PIC16C66 Rev. A Silicon Errata Sheet

The PIC16C66 (Rev. A) parts you have received conform functionally to the Device Data Sheet (DS30234D), except for the anomalies described below.

Clarifications/Corrections to the Data Sheet:

FIGURE 1: WRITES TO TIMER1 (EXTERNAL CLOCK/OSCILLATOR MODE)

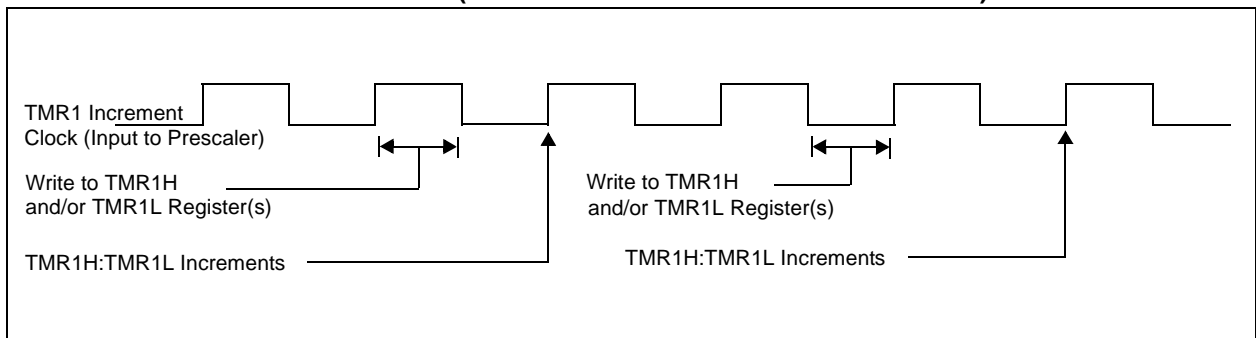
3. Module: Timer1

The operation of Timer1 needs some clarification when the timer registers are written and the TMR1ON bit is set.

The internal clock signal, that is the input to the TMR1 prescaler, affects the incrementing of Timer1 (TMR1H:TMR1L registers and the Timer1 prescaler). When the Timer1 registers are NOT written, the Timer1 will increment on the rising edge of the TMR1 increment clock.

When the TMR1H and/or TMR1L registers are written while this clock is high, TMR1 will increment on the next rising edge of this clock.

When the TMR1H and/or TMR1L registers are written while this clock is low, TMR1 will not increment on the next rising edge of this clock, but must first have a falling clock and the rising clock for TMR1 to increment.

Figure 1 shows the two cases of writes to the TMR1H and/or TMR1L registers. Due to the V_{IH} and V_{IL} thresholds on the oscillator/clock pins, external Timer1 oscillator components, and external clock frequency, the Timer1 increment clock may not be of a 50% duty cycle.

The TMR1 increment clock is out of phase of the T1OSO/T1CKI pin by a small propagation delay.
